March 2, 2009

RECOMMENDATION FOR THE PROPOSED DEVELOPMENT OF A MIXED-USE BUILDING AT 10 DOCK STREET

090181 ZMK – 090182 ZRK – 090183 ZSK – 090184 ZSK

Illustration: 1

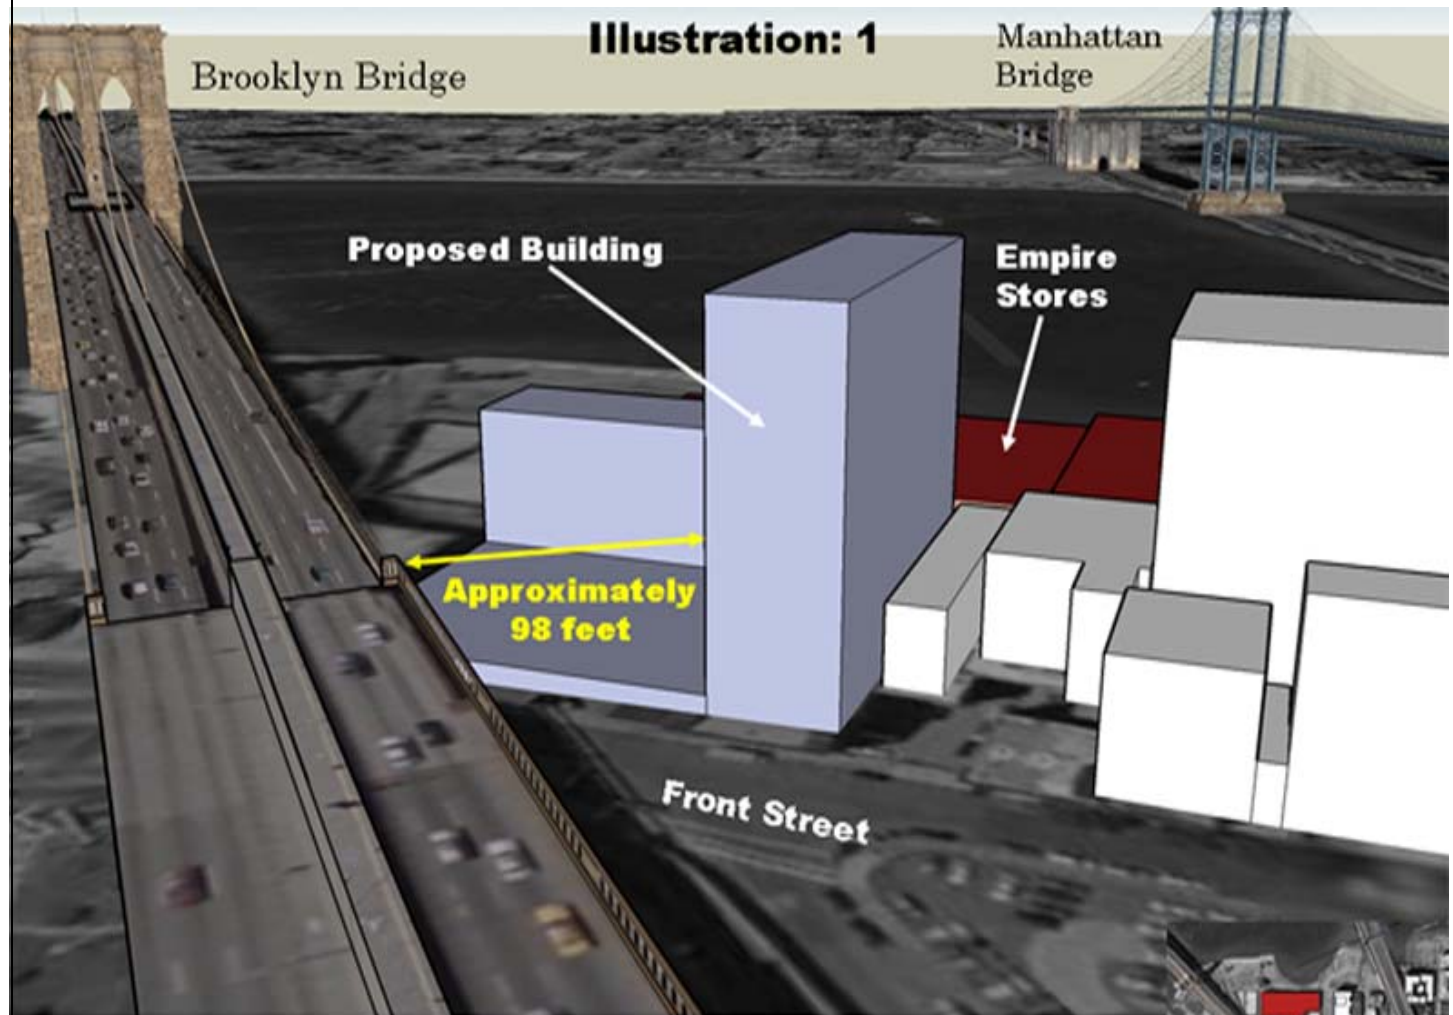
The borough president believes that the linear distance of approximately 98 feet separating the "tower" and the Brooklyn Bridge is inadequate (see attached illustration #1). The "tower" would loom over the bridge and significantly obscure views from the pedestrian walkway. As noted previously, the existing M1-2 zoning would allow an as-of-right building taller than 200 feet within 70 linear feet of the bridge. He believes that no building should be taller than the bridge within 150 linear feet of the span.

1. That the following bulk modifications be made, That,
 - A. The tower be not less than 150 feet from the span of the Brooklyn Bridge in lieu of the approximately 98 feet proposed; and, a setback of not less than 70 feet from Front Street (disapproval of the General Large Scale Special Bulk Permit setback encroachment request) as opposed to no setback as proposed.
 - B. The Water Street street-wall elevation not exceed 80 feet, as opposed to the 93 feet proposed, with no setbacks except for bulkhead and the tower section of the building.
 - C. The tower along Water Street be setback at least 15 feet as opposed to no setback as proposed (i.e., disapproval of that portion of the General Large Scale Special Bulk Permit [090183 ZSK] regarding the setback encroachment request).

Illustration: 2

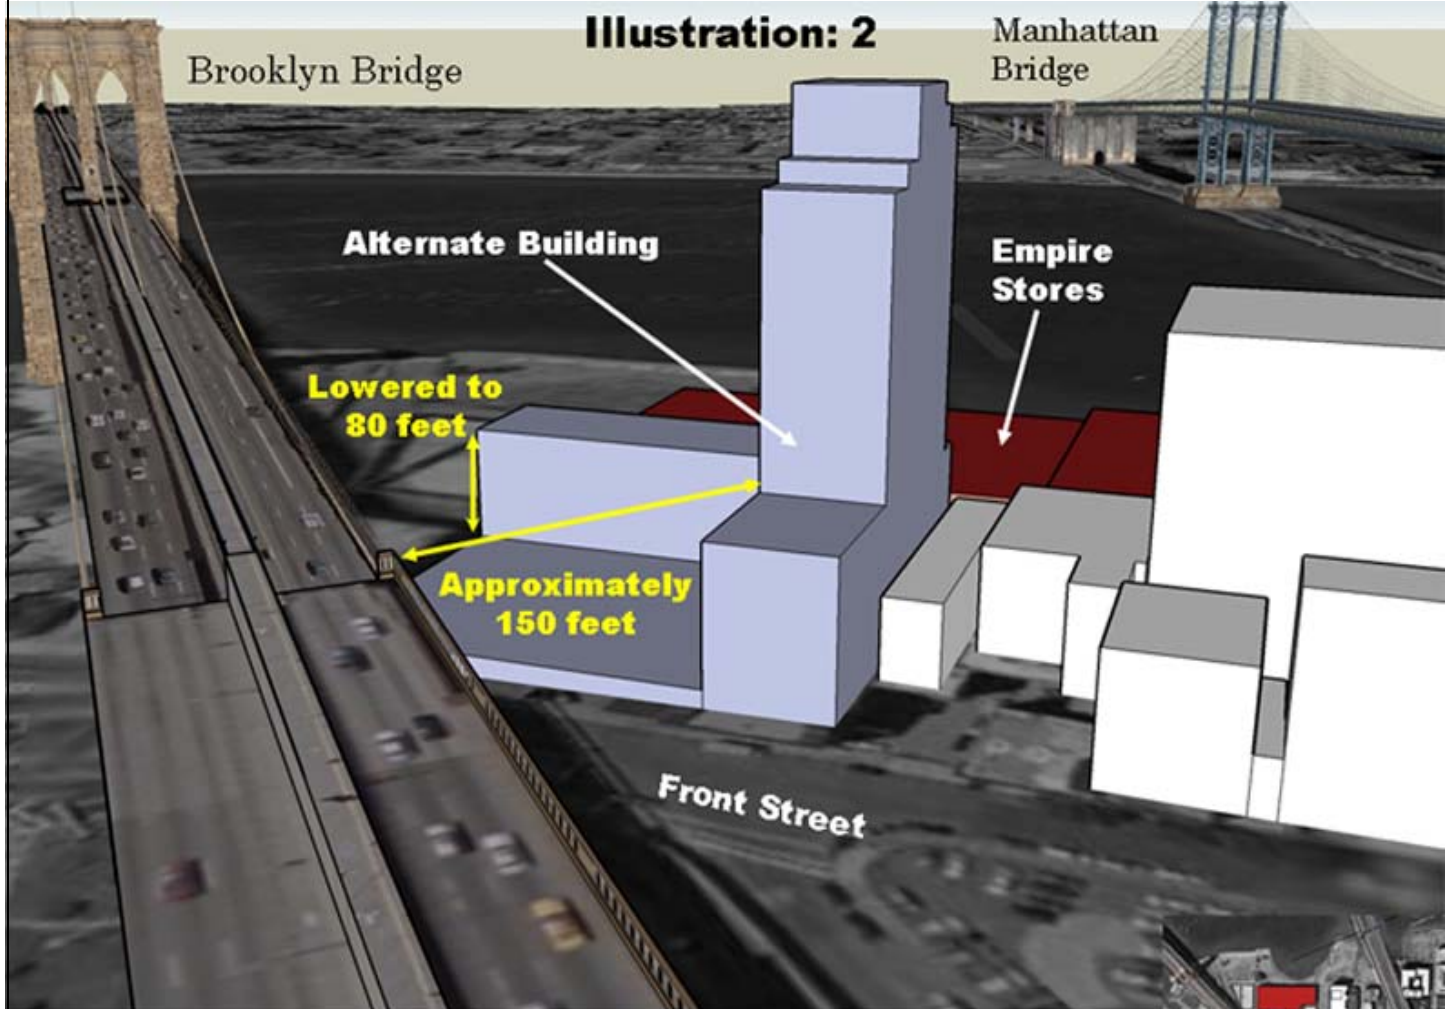
Setting the tower at least 70 feet from the street wall along Front Street appears to be sufficient (see attached illustration #2). By substantially reducing the footprint of the "tower" the extent where views would be obscured would be diminished.

Illustration: 3

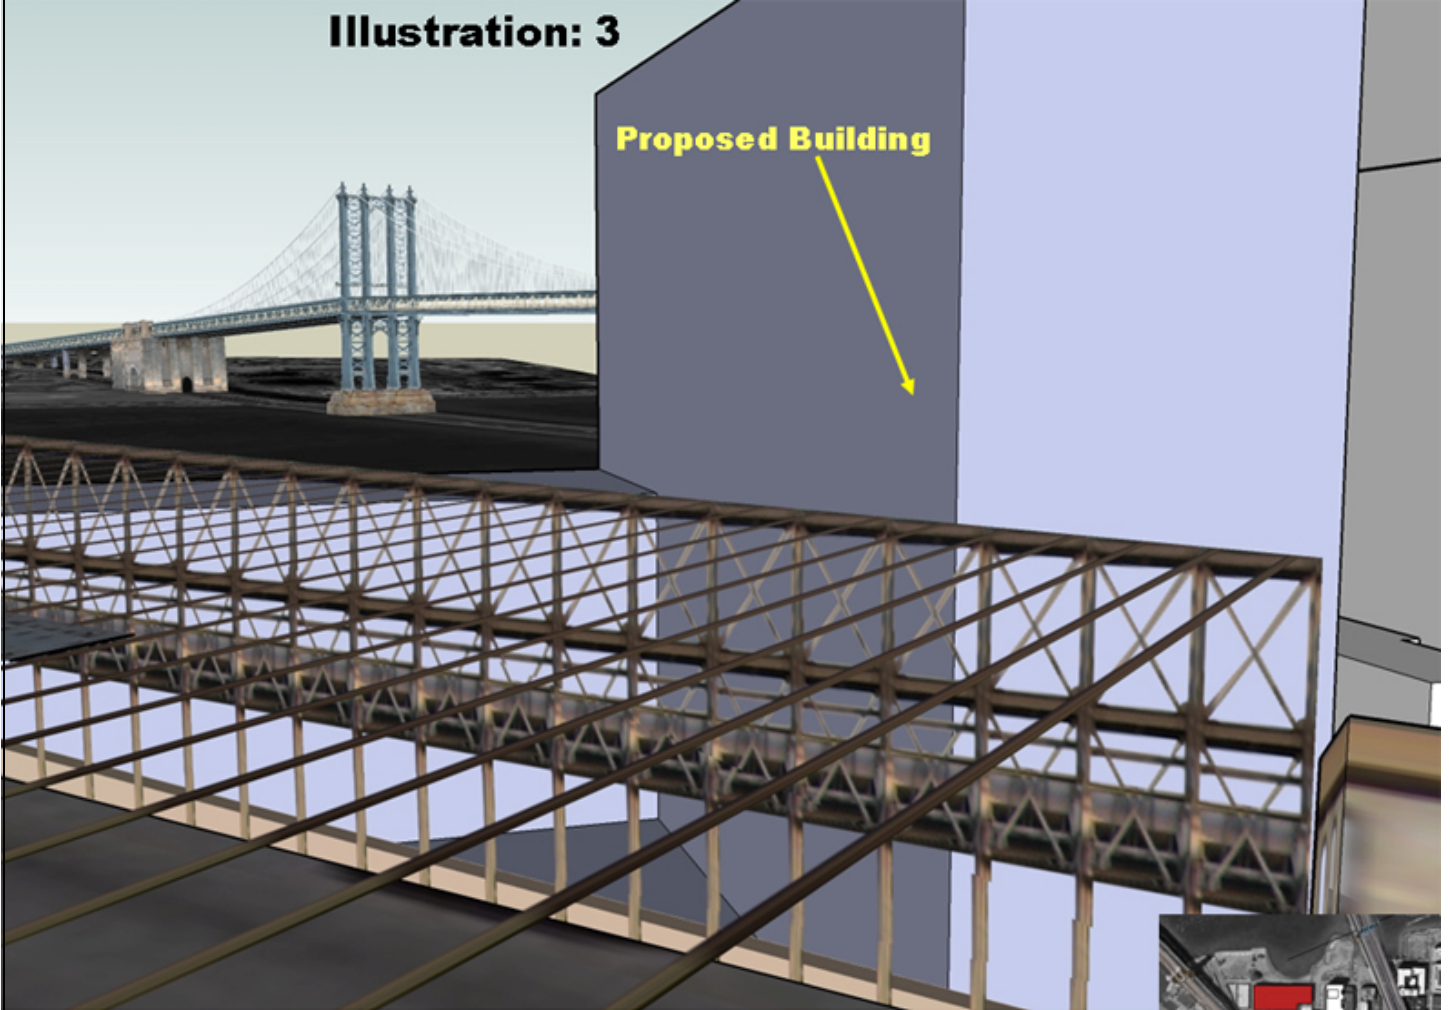
As previously noted, the borough president recognizes that the existing M1-2 zoning allows for a very tall building. In such a scenario, there would be limited zoning controls that effect building placement within the bowl, though the tower footprint would be substantially less than what is proposed. In consideration of the as-of-right possibility, the borough president believes that restricting the tower to 150 linear feet of the Brooklyn Bridge in combination with a street wall height limit of 80 feet along Water Street would substantially preserve the bowl effect (see attached illustration #4).

Illustration: 7

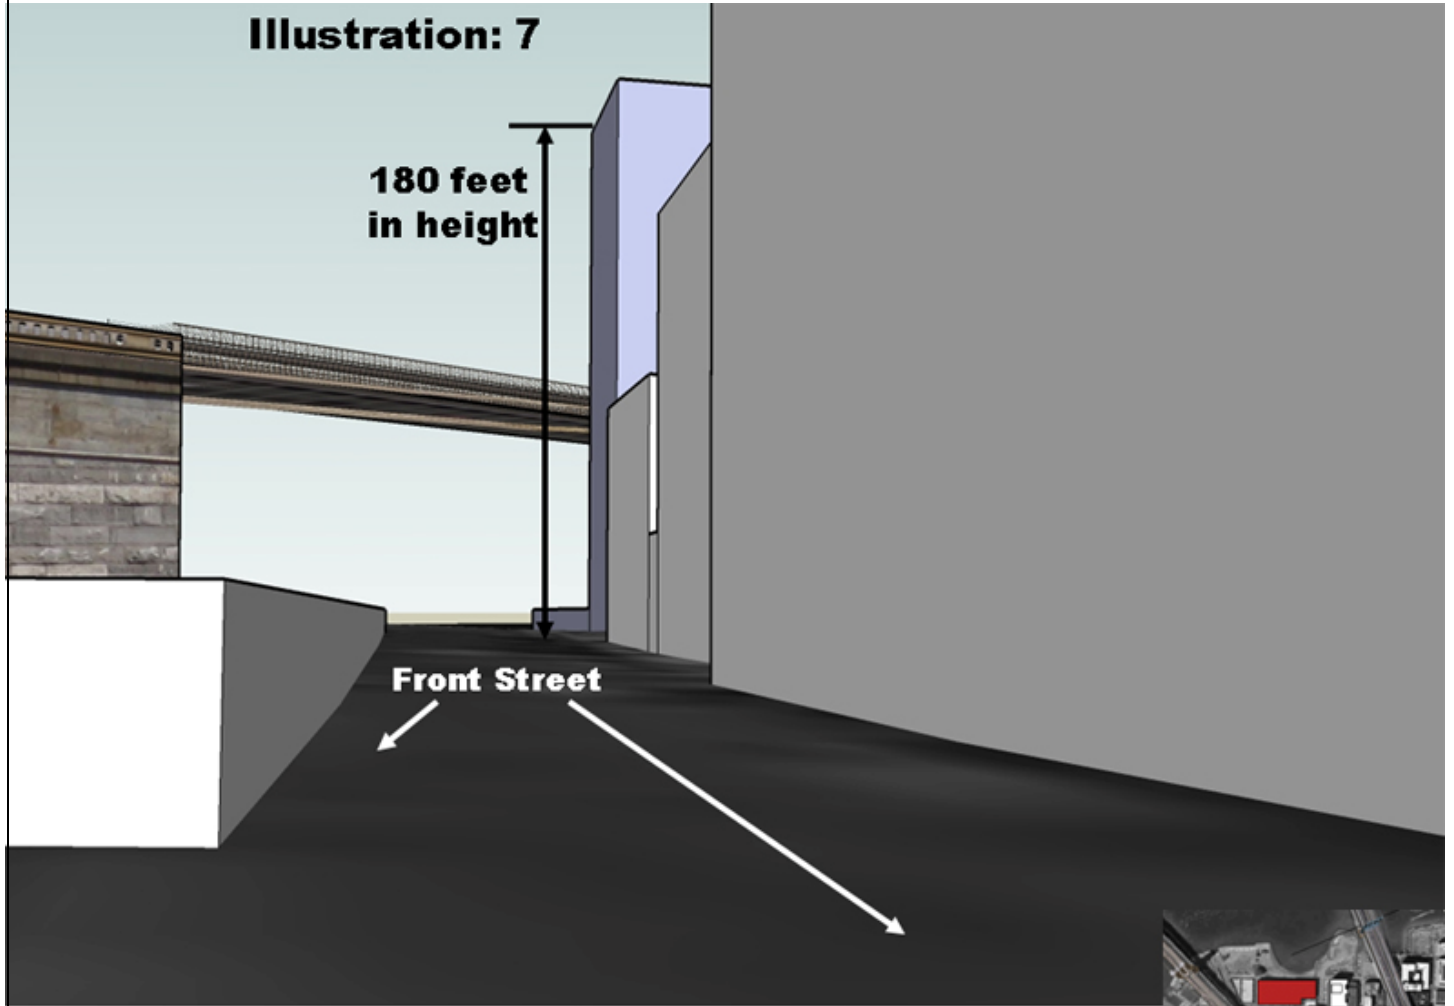
The proposed tower of 56 feet on Front Street, as previously noted, should setback at least 70 feet from the street wall rather than the proposed zoning height of 180 feet (see attached illustration #7). The height of this street wall should be consistent with the buildings east of the site on this block (see attached illustration #8). Those buildings, zoned M1-2/R8A, would mandate a zoning street wall height up to 85 feet. This is reflective of the recent construction at the corner of Front and Main Streets.

- D. The Front Street tower street wall elevation not exceed 85 feet as opposed to the 180 feet as proposed (i.e., disapproval of that portion of the General Large Scale Special Bulk Permit [090183 ZSK] regarding the setback encroachment request).
2. That the affordable housing be codified by a covenant or other legal instrument to run with the property, stating that twenty percent of the residential floor area will be developed as affordable housing.
 3. That for bicycle parking spaces within the public parking garage, such parking shall be provided without fees.
